Volume III: Public Participation Report

Proposed Emvelo Wind Energy Facility and Associated Grid Infrastructure, near Ermelo, Mpumalanga

DRAFT FOR PUBLIC COMMENT

15 July 2025

Emvelo WEF Scoping Report

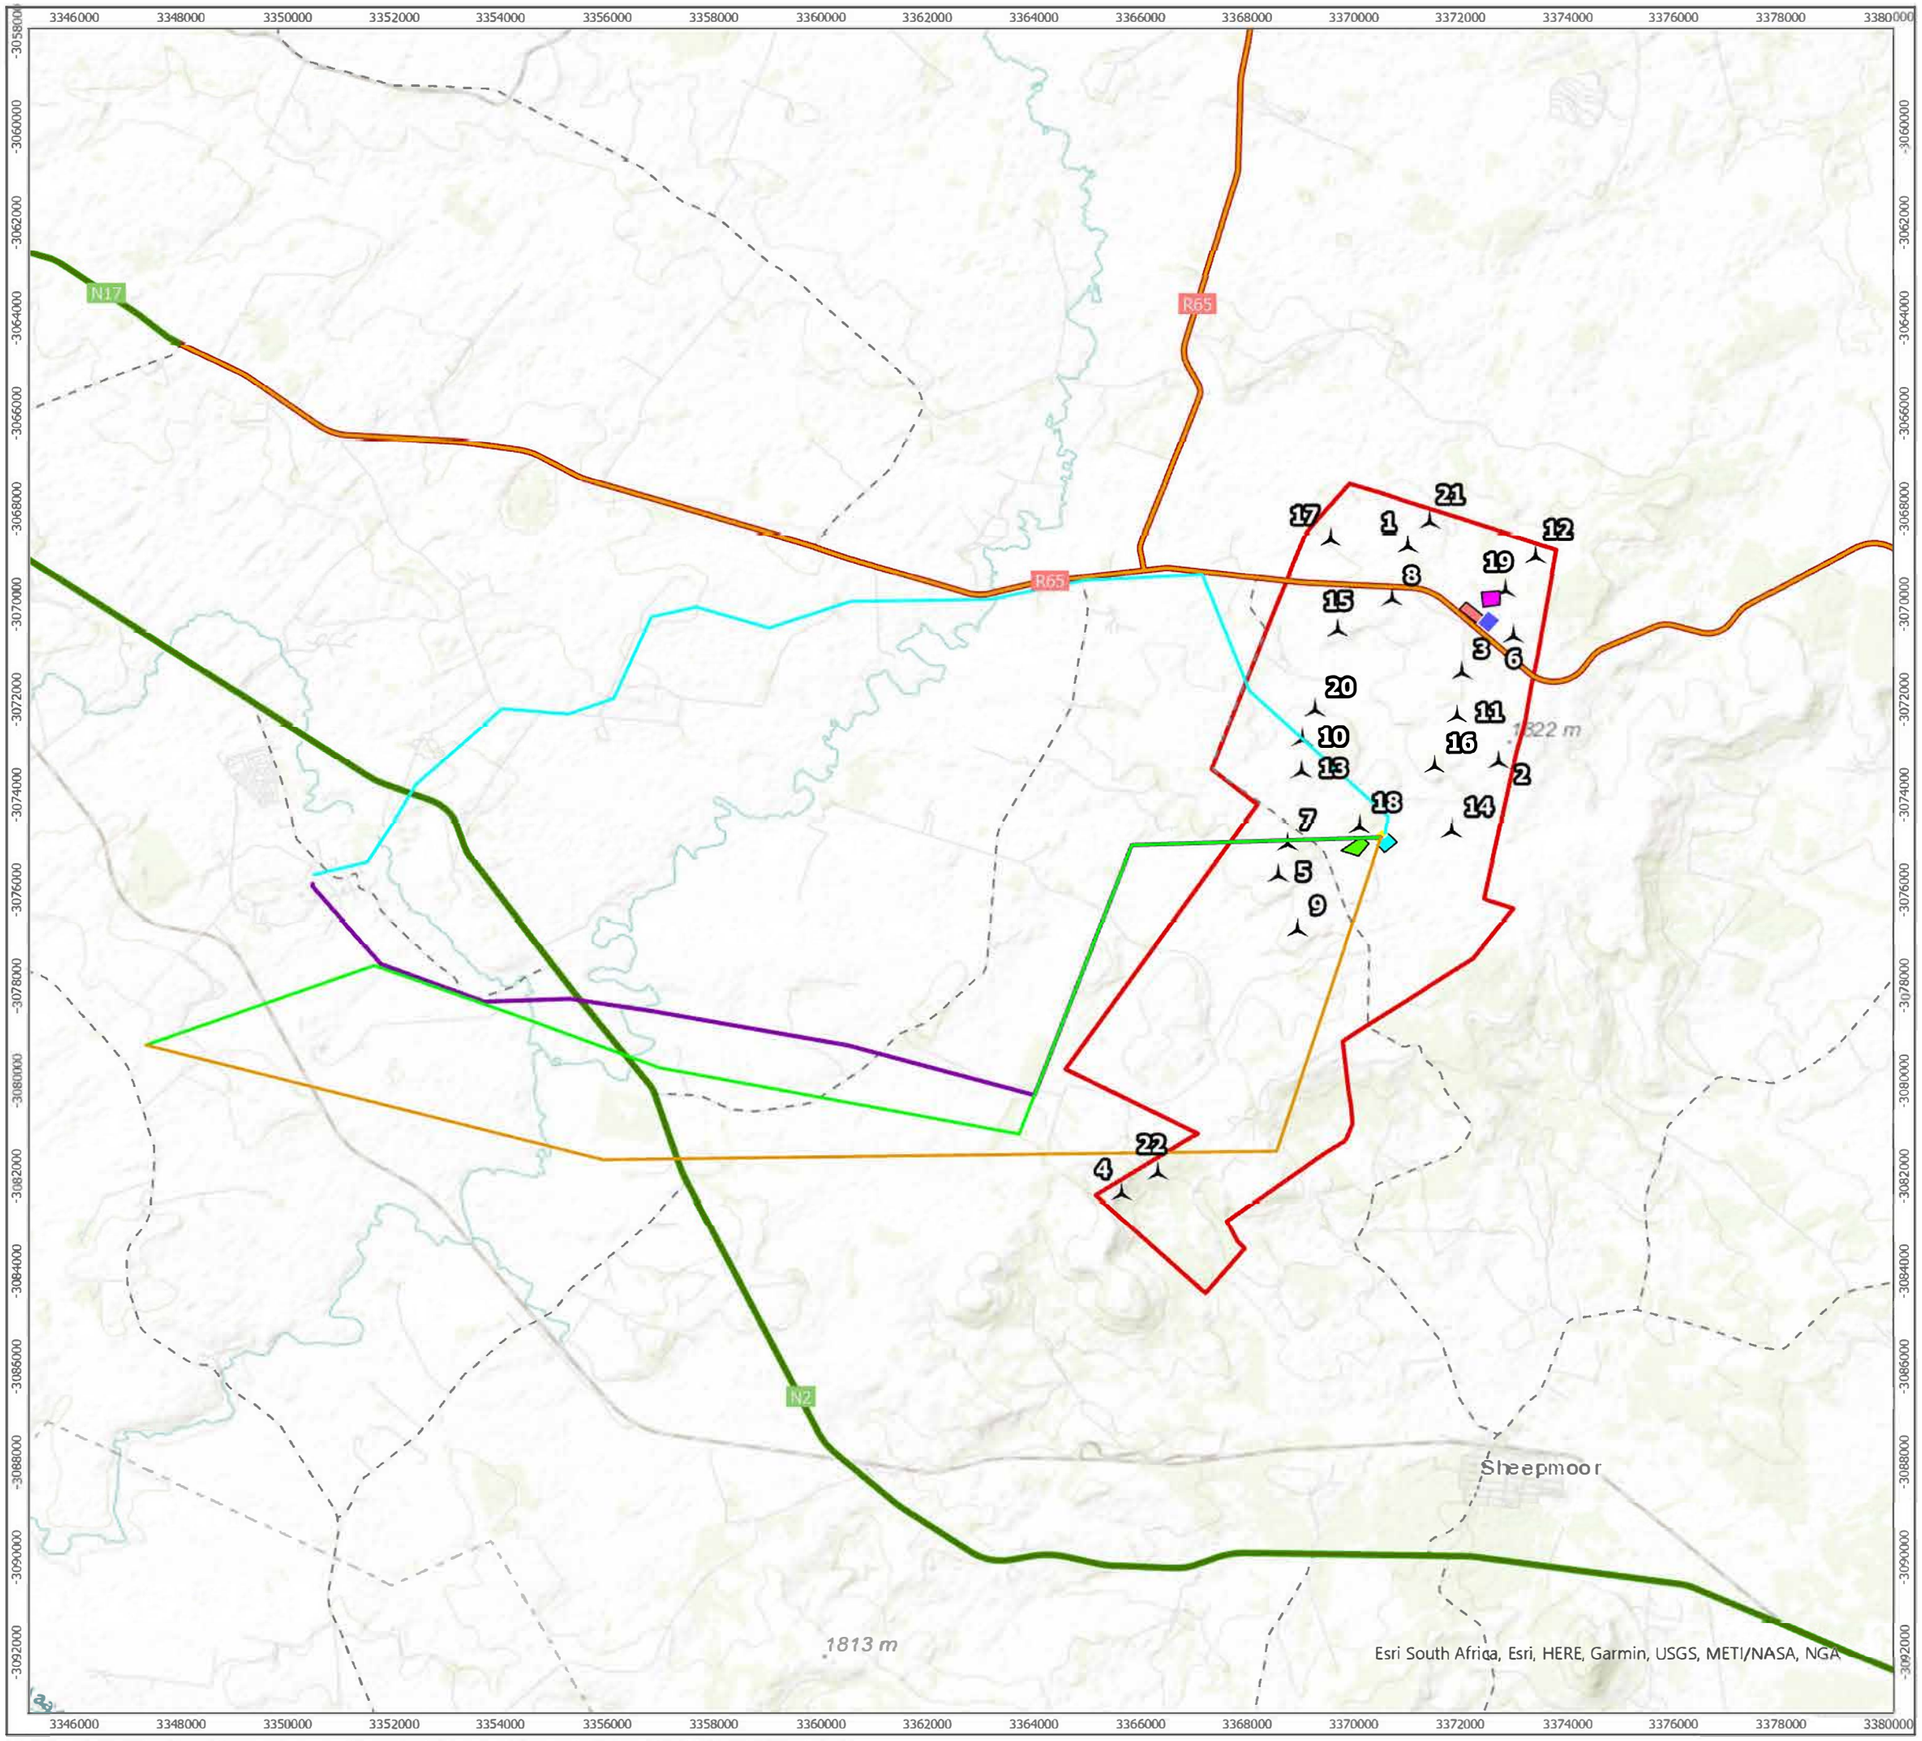
1. Let us try to explain it ....With reference to one of ERM own drawings you sent via email to me, Preferred Site Development Plan, Figure 3 attached for your convenience. It shows tree areas bordered with a different colour namely BLUE, GREEN and YELLOW.. At the top of the title bloc at the right hand side of Figure 3, just bellow Turbine Locations you find three rectangular figures, top rectangular figure bordered BLUE with description **Sheepmoor WEF 1** next to it,middle rectangular figure bordered GREEN with description **Sheepmoor WEF 2** next to it and then underneath that a rectangular figure bordered YELLOW with description **Sheepmoor WEF 3** next to it. Do I really need to go further?

Figure 1. MBSP based terrestrial biodiversity assessment for the Emvelo Wind Energy Facility.

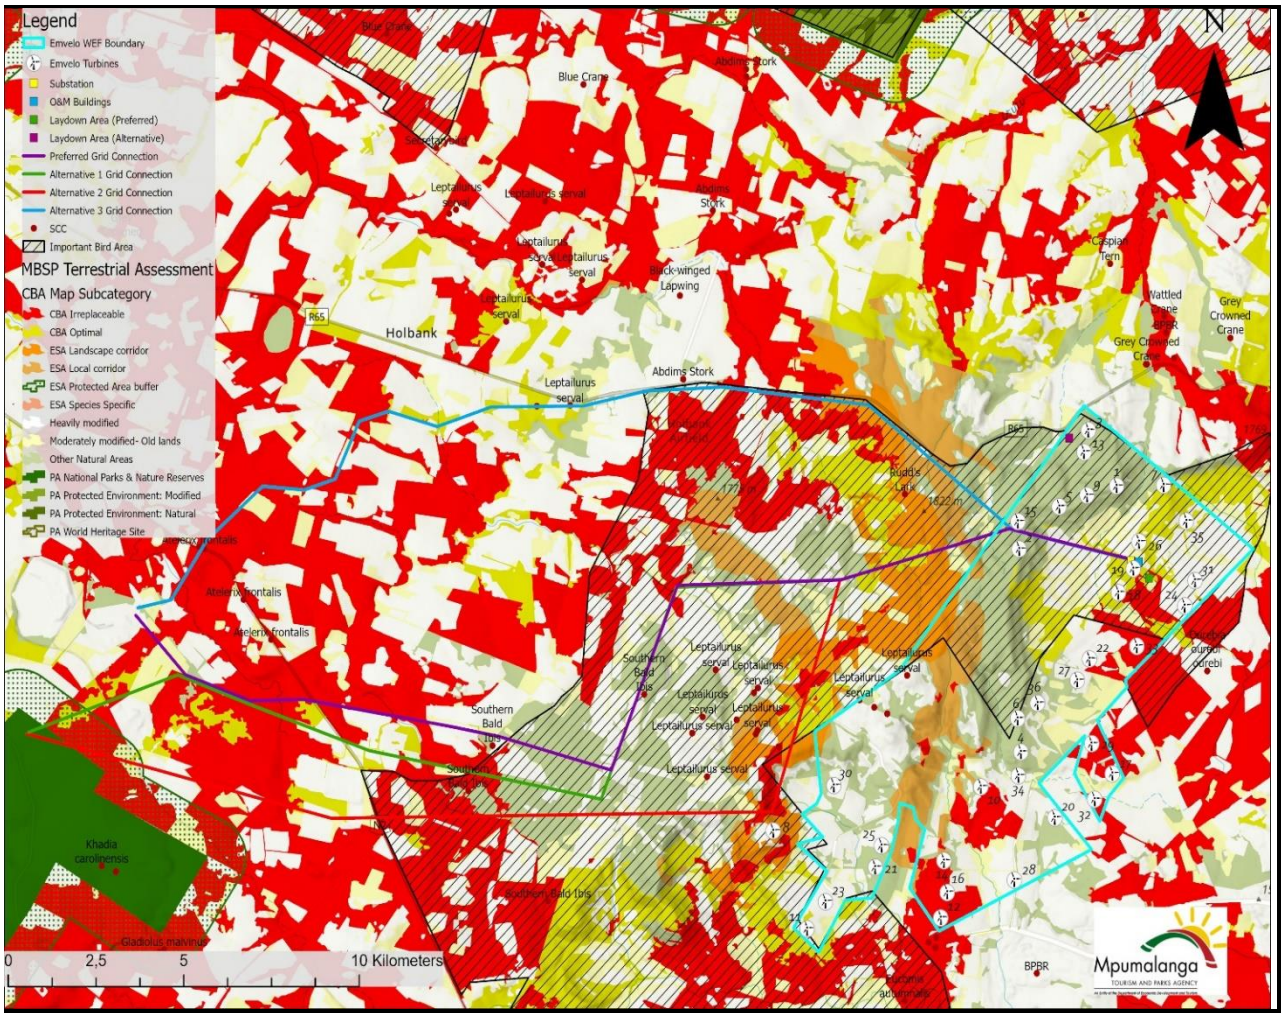
According to the MBSP terrestrial assessment map (figure 1) the proposed development will occur within CBA Irreplaceable, CBA Optimal, ESA Landscape corridor, ESA Ecological Corridor, Important Bird Areas (IBA), other natural areas, moderately modified- old lands and heavily modified area (Degraded). According to the freshwater assessments map (figure 2), the proposed development will occur within a CBA Aquatic River, CBA wetlands, ESA wetlands, ESA Strategic water source, ESA Important sub-catchments other natural areas and heavily modified area (Degraded).

Figure 3. MBSP based Intact Grasslands map for the Emvelo Wind Energy Facility.

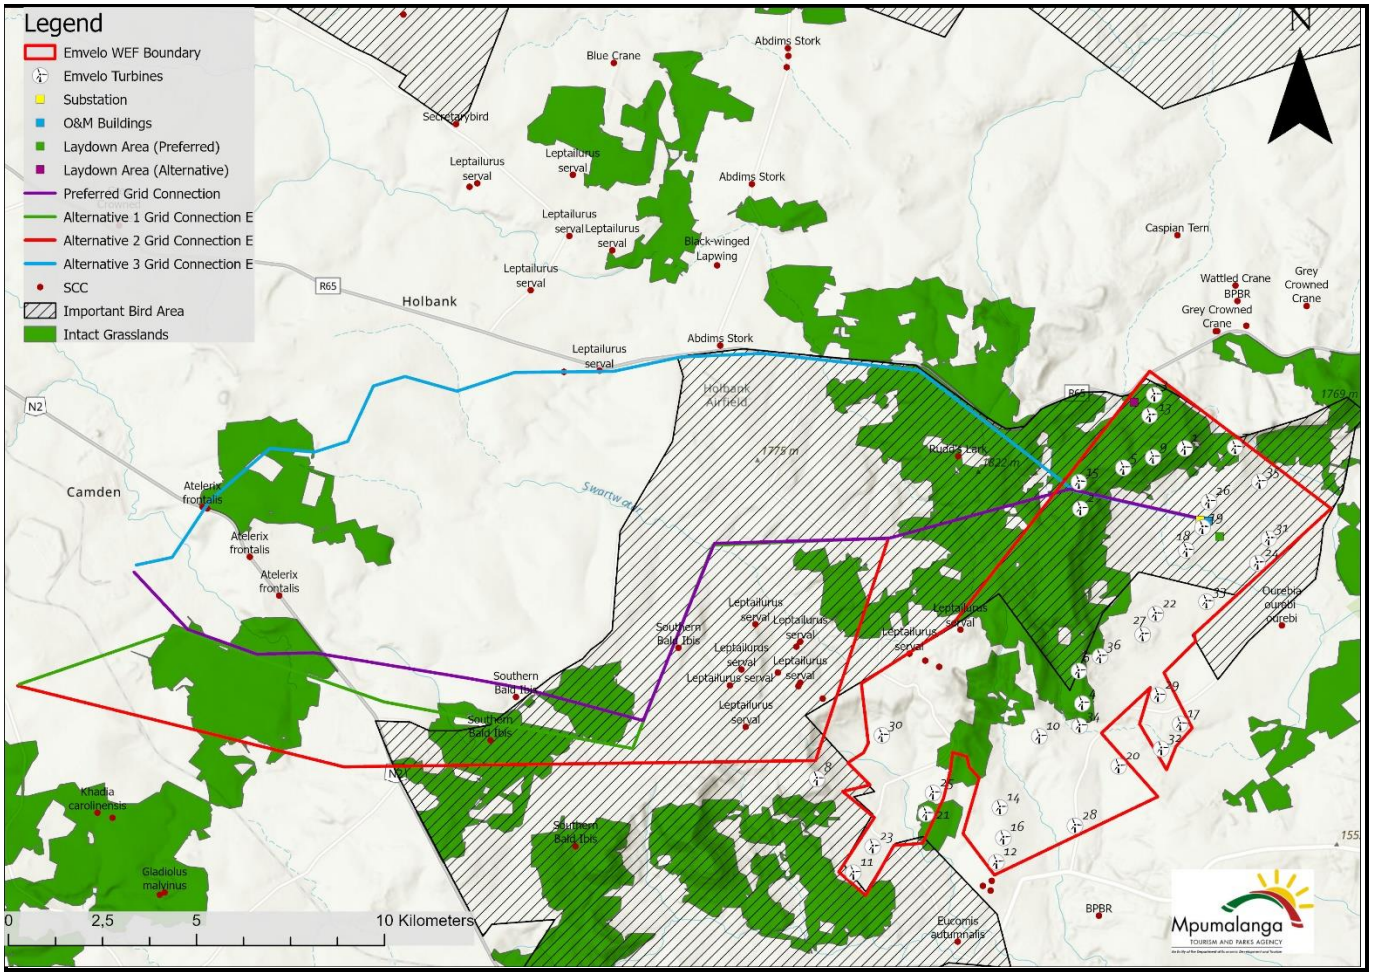
The MTPA is concerned with a number of turbines that are in no-go areas or highly sensitive areas. There are ten (10) turbines that are located within the intact grasslands which are turbines 1, 2, 3, 4, 5, 6, 7, 9, 13 and 15 (refer to Figure 3), intact grasslands are crucial for supporting threatened avifauna and these turbines will compromise that biodiversity objective. The MBSP specifically incorporated climate change into spatial priorities through the prioritisation of the connectivity of remaining intact grassland patches in the province, as they provide habitat for species to thrive, and allow for their dispersal.

Figure 1. MBSP based terrestrial biodiversity assessment for the Emvelo Wind Energy Facility.

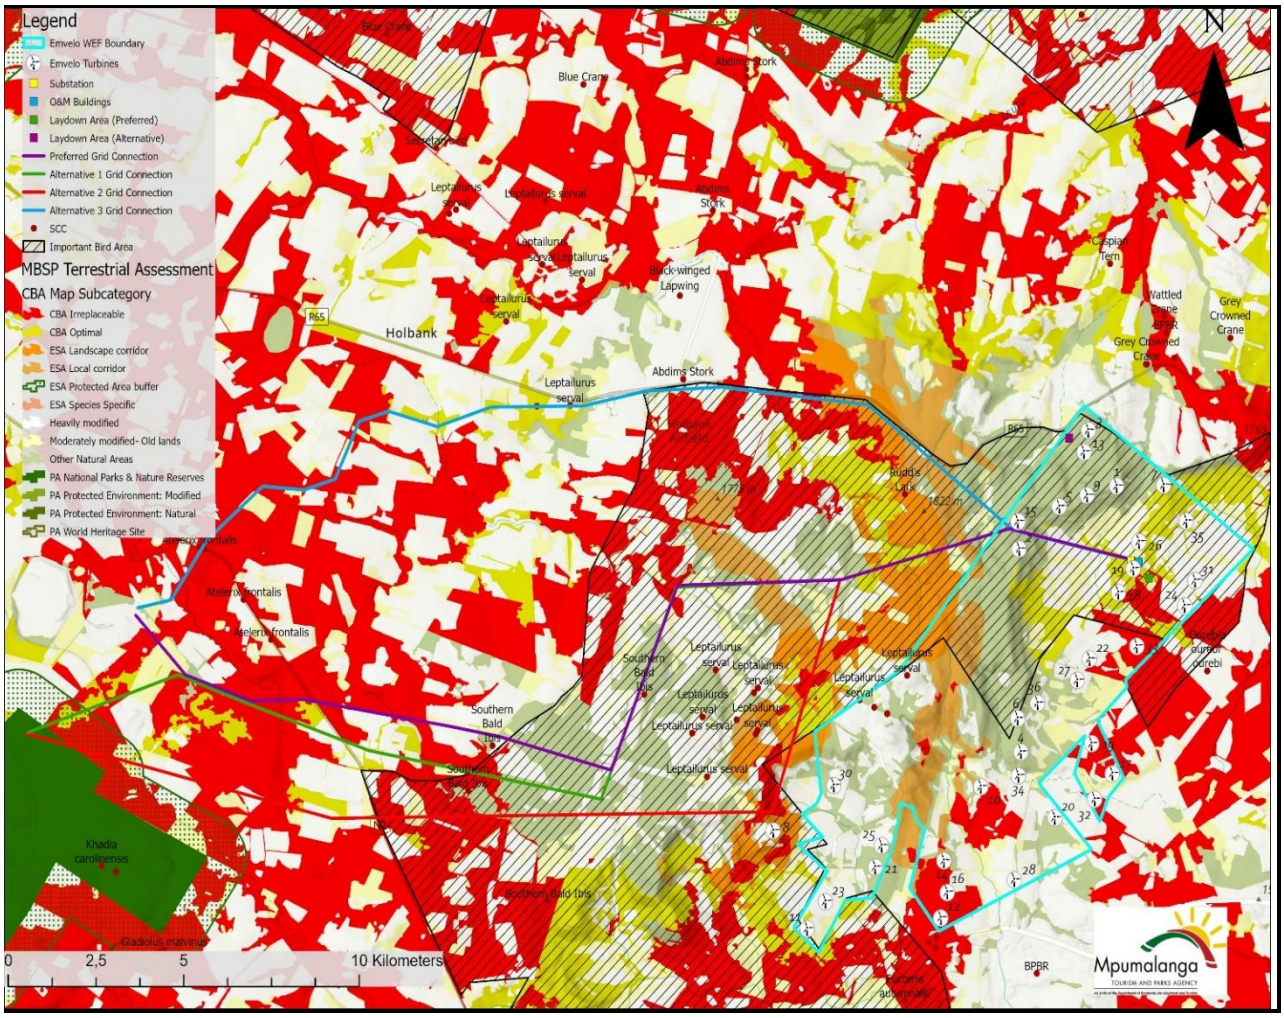
According to the MBSP terrestrial assessment map (figure 1) the proposed development will occur within CBA Irreplaceable, CBA Optimal, ESA Landscape corridor, ESA Ecological Corridor, Important Bird Areas (IBA), other natural areas, moderately modified- old lands and heavily modified area (Degraded). According to the freshwater assessments map (figure 2), the proposed development will occur within a CBA Aquatic River, CBA wetlands, ESA wetlands, ESA Strategic water source, ESA Important sub-catchments other natural areas and heavily modified area (Degraded).

Figure 3. MBSP based Intact Grasslands map for the Emvelo Wind Energy Facility.

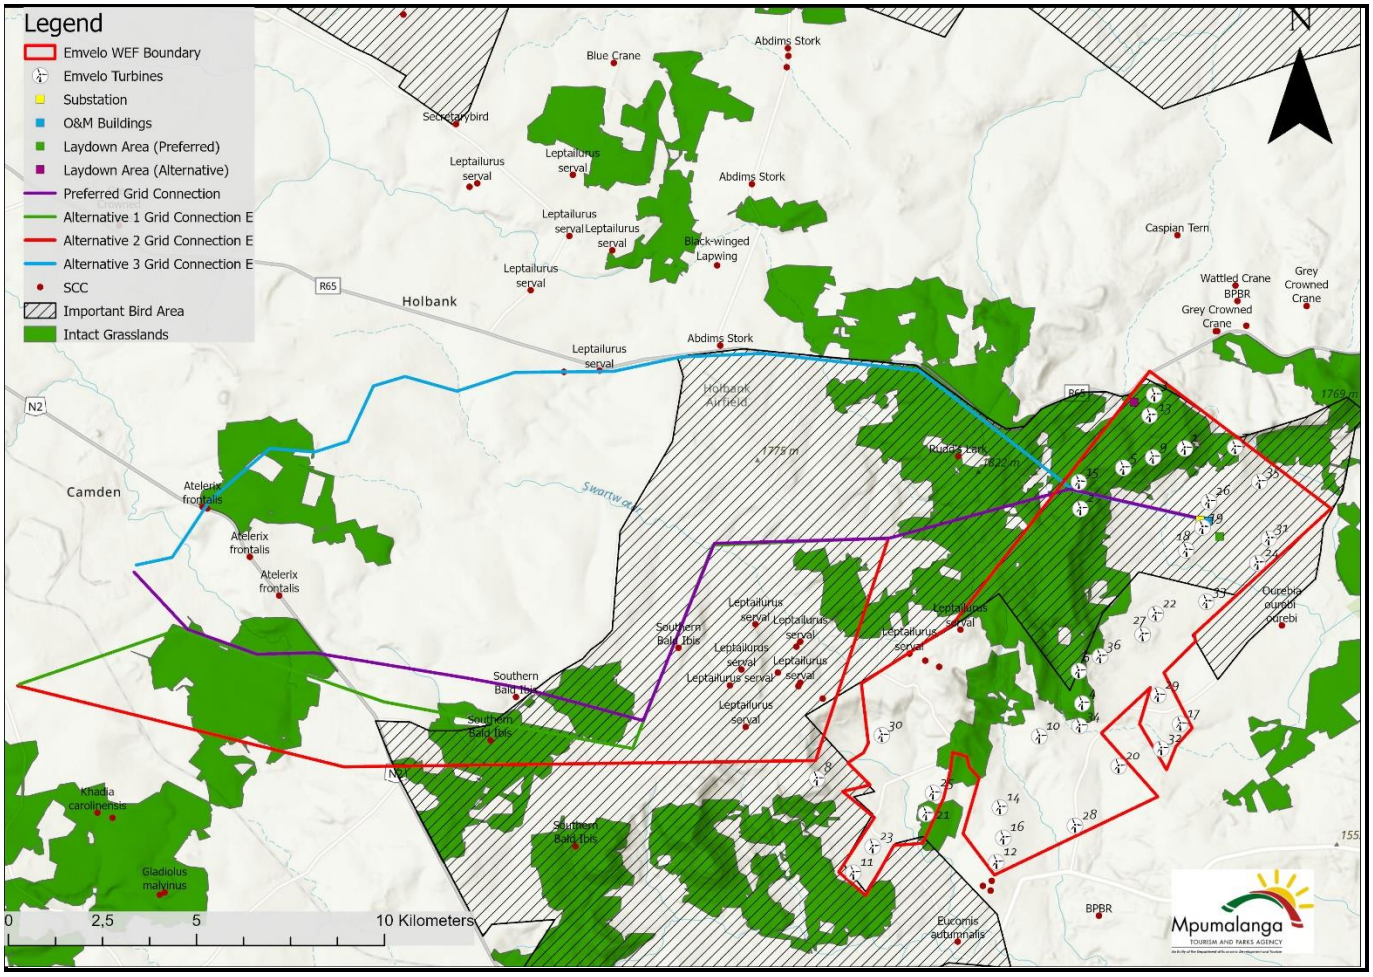
The MTPA is concerned with a number of turbines that are in no-go areas or highly sensitive areas. There are ten (10) turbines that are located within the intact grasslands which are turbines 1, 2, 3, 4, 5, 6, 7, 9, 13 and 15 (refer to Figure 3), intact grasslands are crucial for supporting threatened avifauna and these turbines will compromise that biodiversity objective. The MBSP specifically incorporated climate change into spatial priorities through the prioritisation of the connectivity of remaining intact grassland patches in the province, as they provide habitat for species to thrive, and allow for their dispersal.
